SSS-FSAR

QUESTION 211.1

SUSQUEHANNA STEAM ELECTRIC STATION
UNITS 1 AND 2
FINAL SAFETY ANALYSIS REPORT

FSAR FIGURE 211.4-1

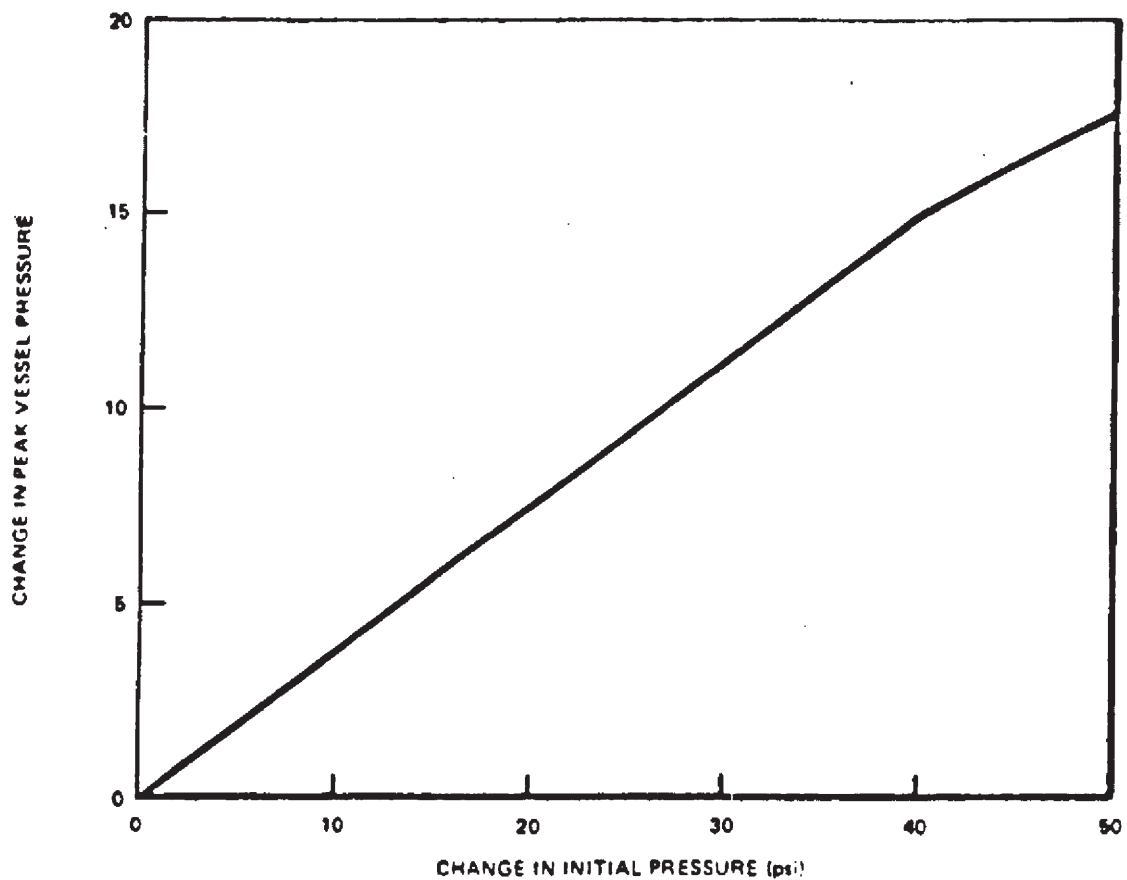
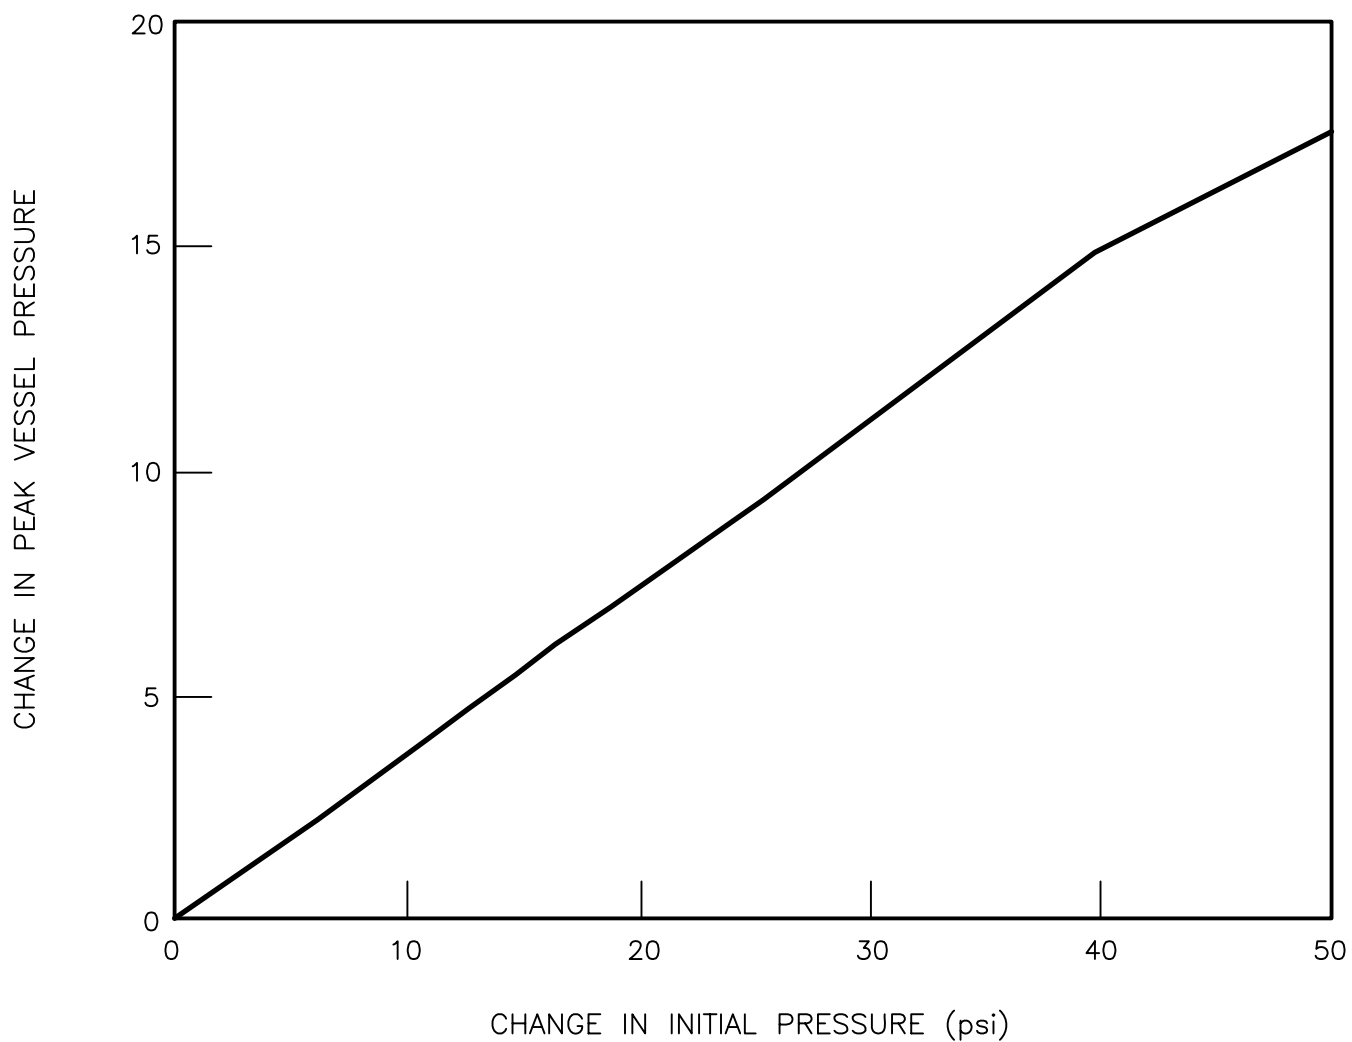
Acceptance Criterion II.2.b of SRP 5.2.2 states that, "All system and core parameters are at the values within the normal operating range, including uncertainties and technical specification limits, which would result in the highest transient pressure." Insufficient information is presented in the FSAR to determine that this acceptance criterion will be met. The applicant should confirm that the overpressure analysis will be based on an initial operating pressure (up to the Technical Specification limit) which will result in the most limiting peak pressure. The applicant should also confirm that the overpressure analysis will include the effects of the ATWS reactor recirculation pump trip on higher reactor pressure.

Acceptance Criterion II.2.c of SRP 5.2.2 states that, "The reactor scram is initiated either by the high pressure signal or by the second signal from the reactor protection system, whichever is later." The applicant has stated that the safety valve sizing analyses can take credit for the first indirect scram, which is the high neutron flux scram. The neutron flux scram occurs before the high pressure scram and results in a lower calculated peak pressure. The applicant should confirm that the safety valve sizing analyses will be based on the SRP acceptance criterion for reactor scram initiation.

The overpressure analysis shown in Chapter 5 of the FSAR assumed the plant is initially operating at 105% steam flow condition with a maximum vessel dome pressure of 1020 psig. The expected maximum operating pressure at 100% power is expected to be 1005 psig, therefore the assumed initial operating pressure of 1020 psig is expected to be conservative relative to expected actual operation. In addition, the nominal high pressure scram set point is expected to be set at 1040 psig. An analysis has been performed for a BWR-3 to investigate the effects of increasing the initial reactor pressure relative to the initial value used in the overpressure protection analysis on the peak system pressure. The conclusion was that increasing the initial operating pressure results in an increase of the peak system pressure, which is less than half the initial pressure increase as shown in Fig. 211.4-1 for the overpressure design transient (i.e., all MSIV closure with indirect high neutron flux scram). The same general trend is expected to exist for Susquehanna. For the Susquehanna project, the proposed technical specification limit on the high reactor pressure scram is 1050 psig. Therefore, the maximum increase in the initial pressure would be limited to only 30 psi and the maximum peak system pressure increase

during the overpressure design transient would be limited to less than 15 psi. Thus the overpressure criteria would still be satisfied.

FSAR FIGURE 211.70-1

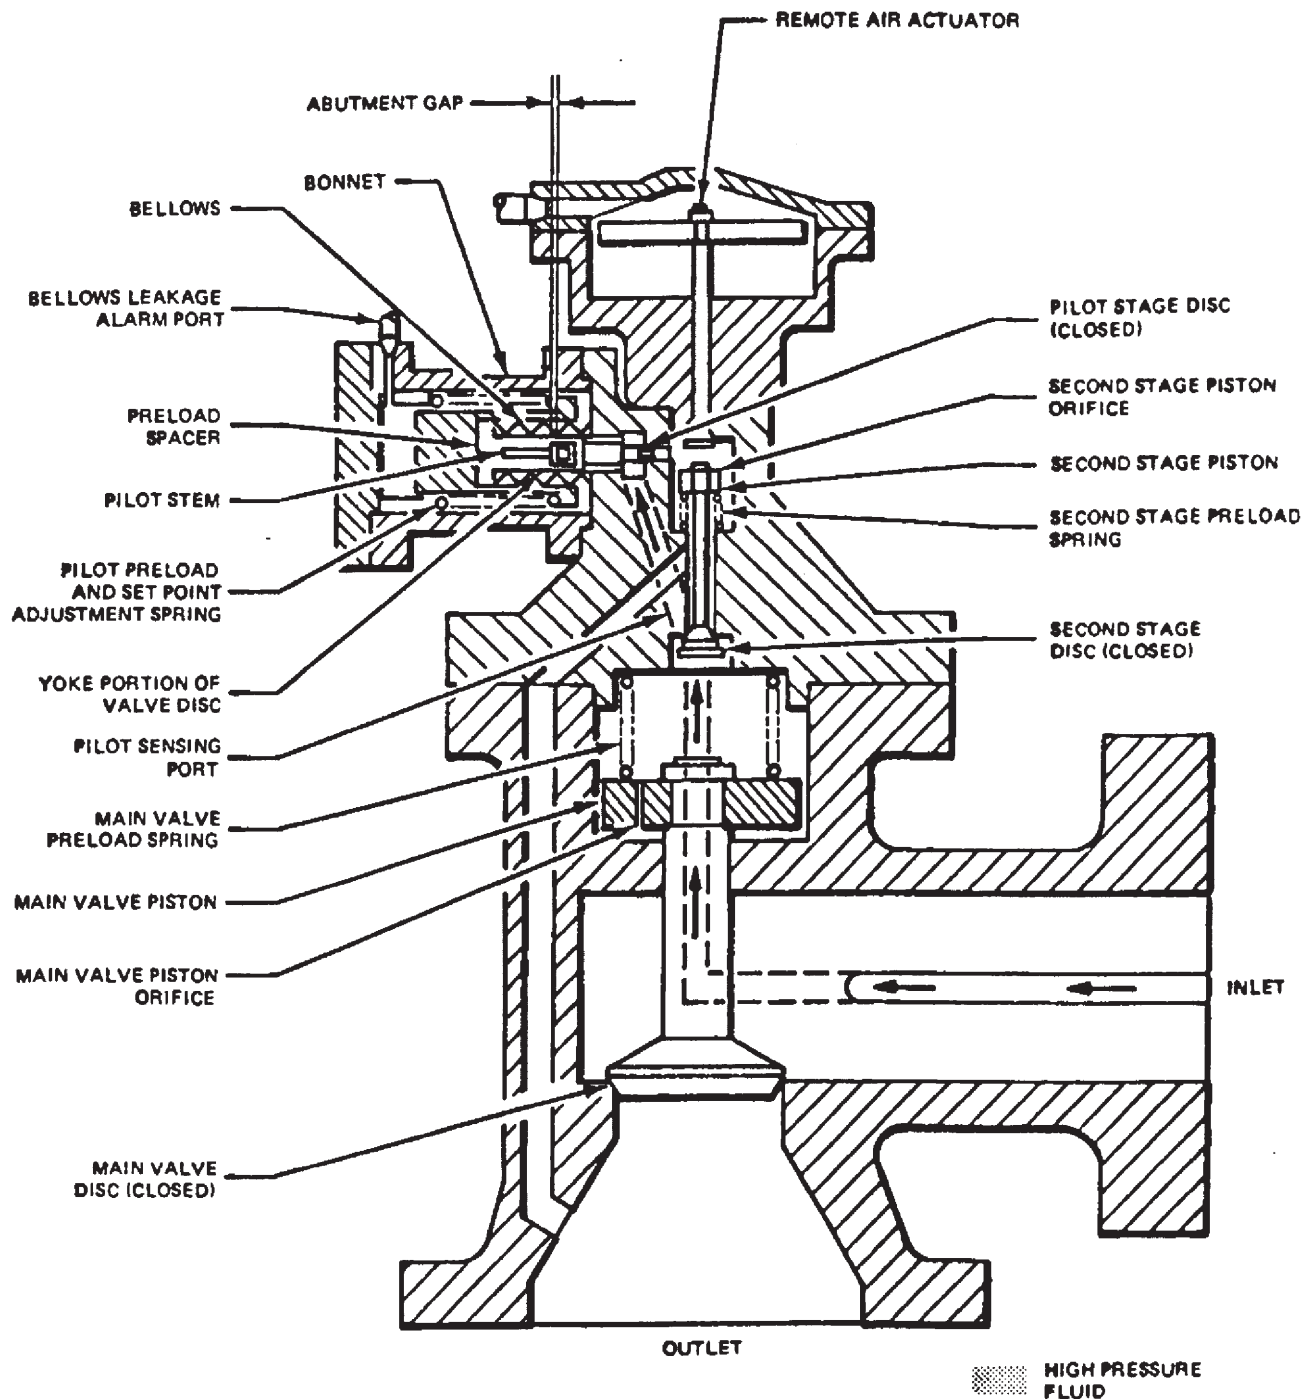
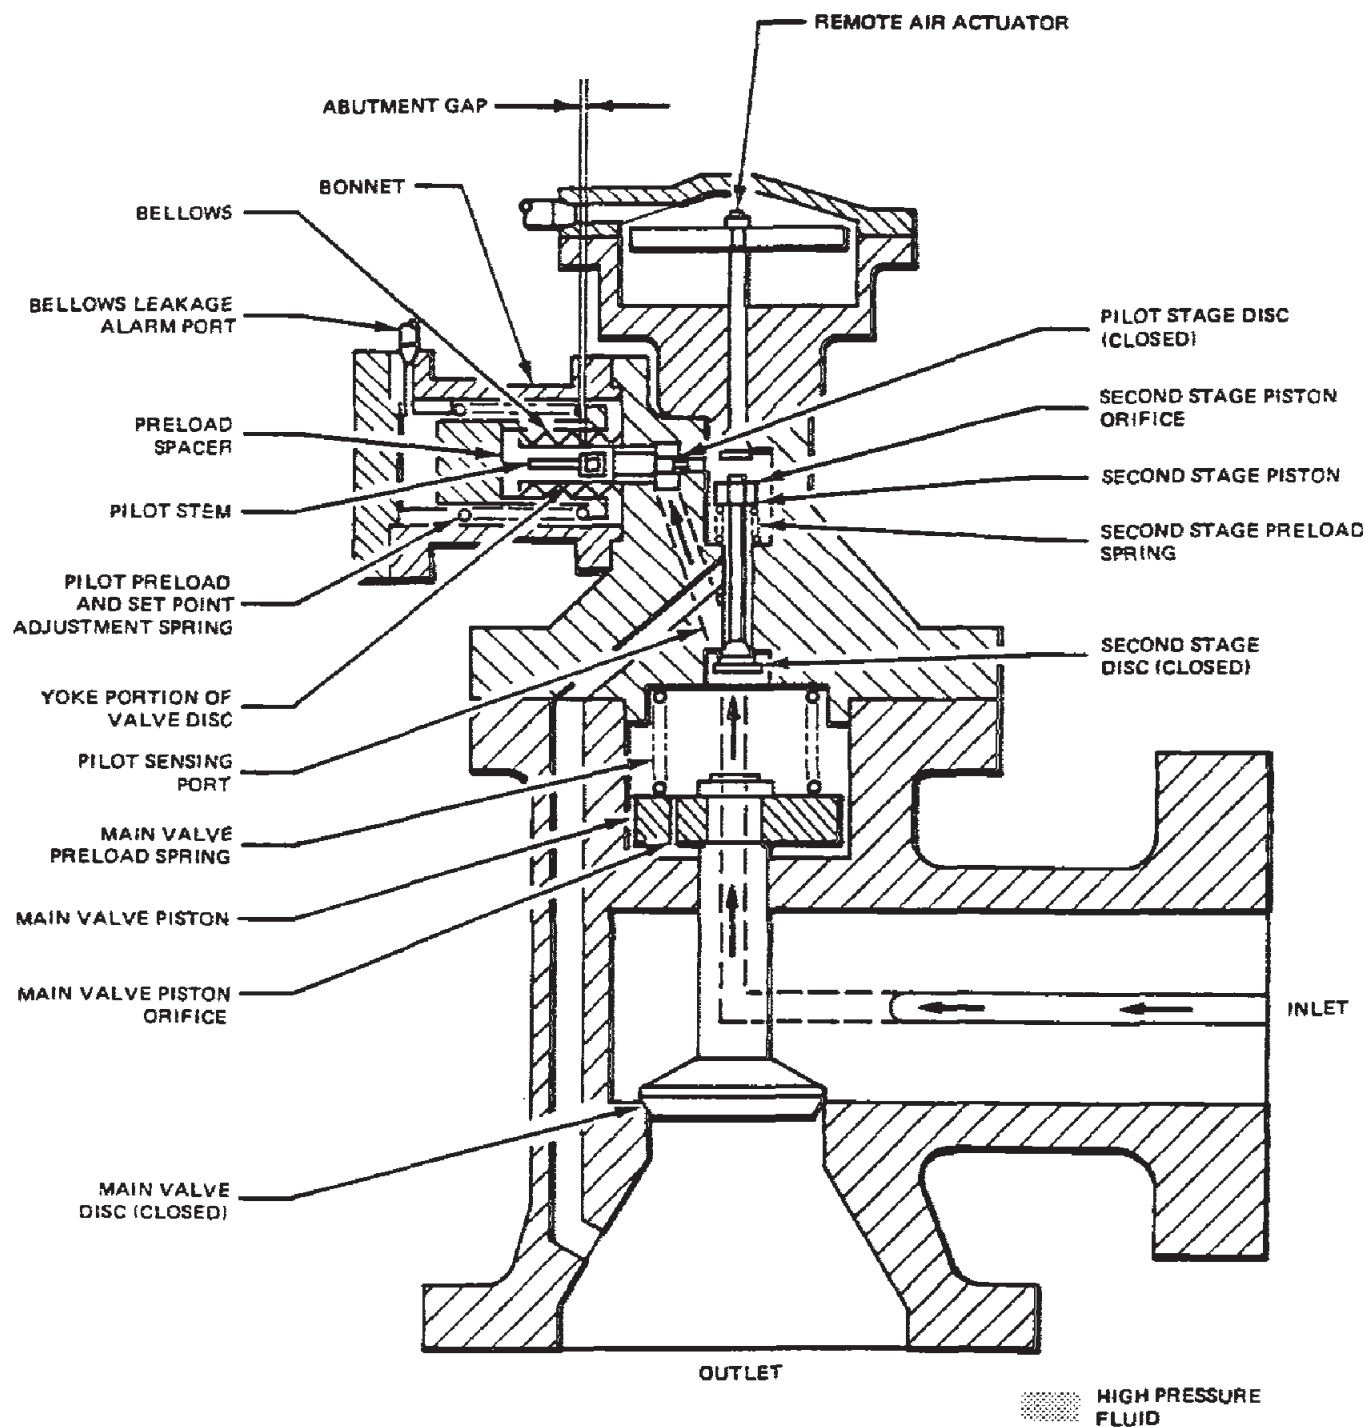
In 7.3.1.12.1.4.2, you state that a dual solenoid-operated pilot valve controls the pneumatic pressure applied to the "bellows actuator" which controls the safety/relief valve directly. In Figure 211.70-2, you show a cross-section of a Crosby valve which has a piston type pneumatic actuator. Also, in Table 211.70-1, you state that the SSES safety/relief valves have no pilot valves but in Section 7.3.1.1a.1.4.2, you state that the air accumulator is sized to provide air for five actuations of the pilot valve following a failure of the pneumatic supply. Resolve these discrepancies.

FIGURE 211.119-1, Rev 47

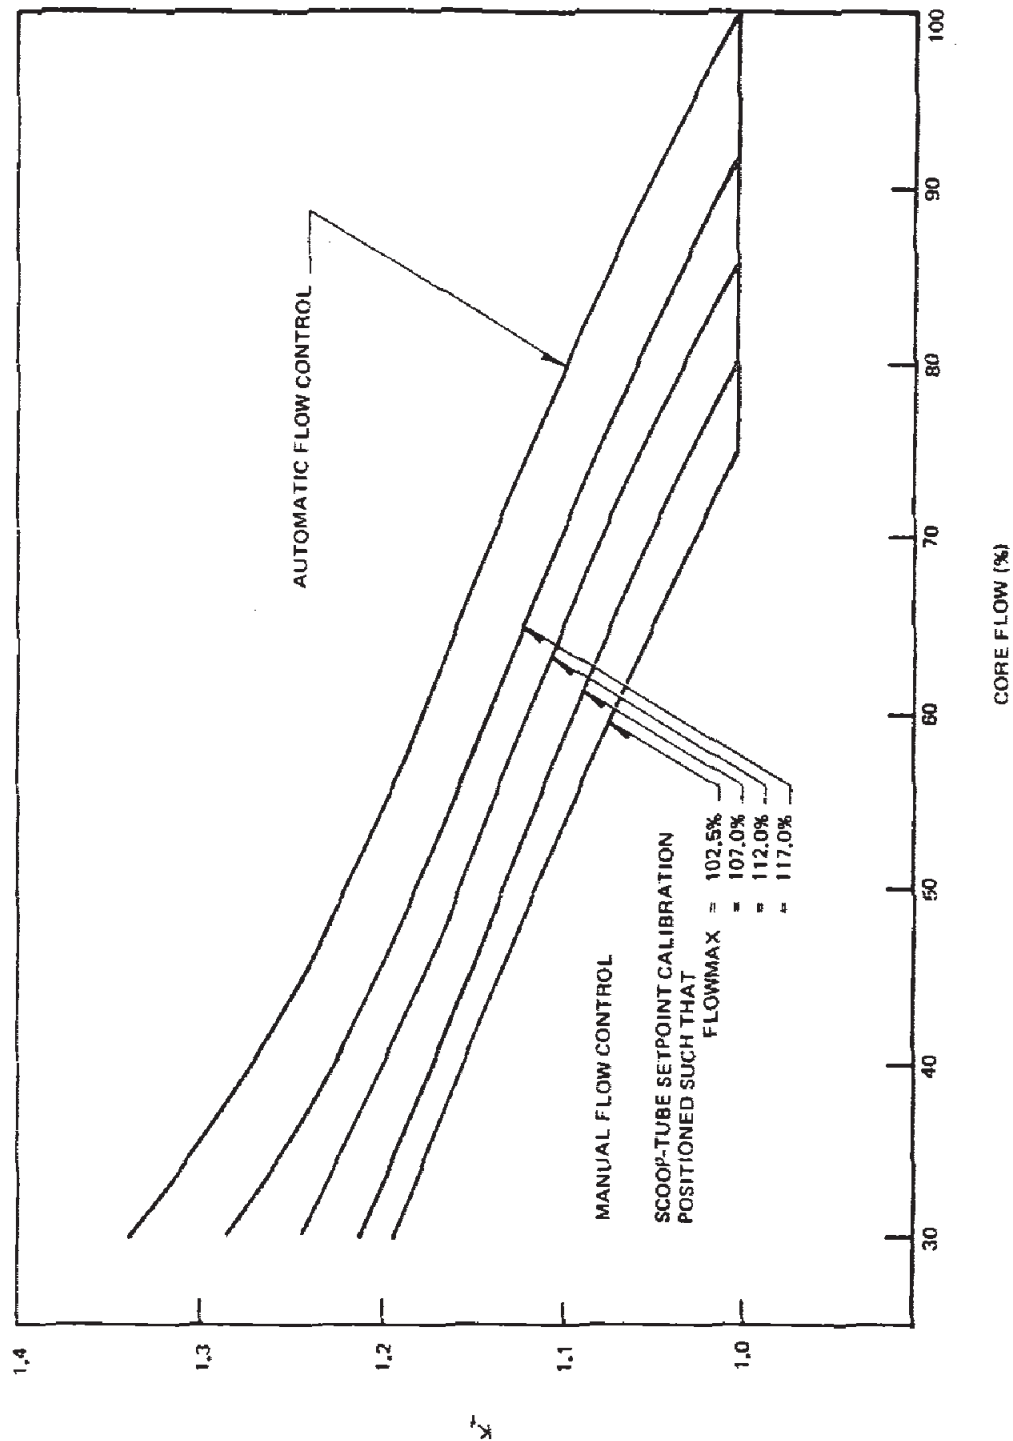
For the recirc flow control failure with increasing flow transient (Section 15.4.5) provide the initial operating MCPR determined at 65% NB rated power and 50% core flow. In addition, provide the K_f factors as a function of core flow for the automatic and manual flow control modes of operation. Furthermore, provide the maximum flow control set point calibration limit (e.g., 100% or 105% of rated flow) for the recirc loop flow control valves used in the transient analysis.

Provide recirculation pump M-G set points for the manual flow control mode assumed in the analysis. Also, you reference the GE topical report NEDO-10802 as the dynamic model to simulate this event. Since NEDO-10802 does not describe the complete event, discuss in greater detail the overall method used to calculate the CPR.

The initial operating MCPR at 65% nuclear boiler rated power (initial core, before power uprate) and 50% core flow was 1.23, assuming slow runout to 102.5% of rated flow.

A plot of K_f factors versus core flow is shown on Figure 211.119-1. Note that the M-G set points for the manual flow control mode are shown on the figure; because flow control is provided by M-G sets there are no flow control valves and thus no flow control set points.
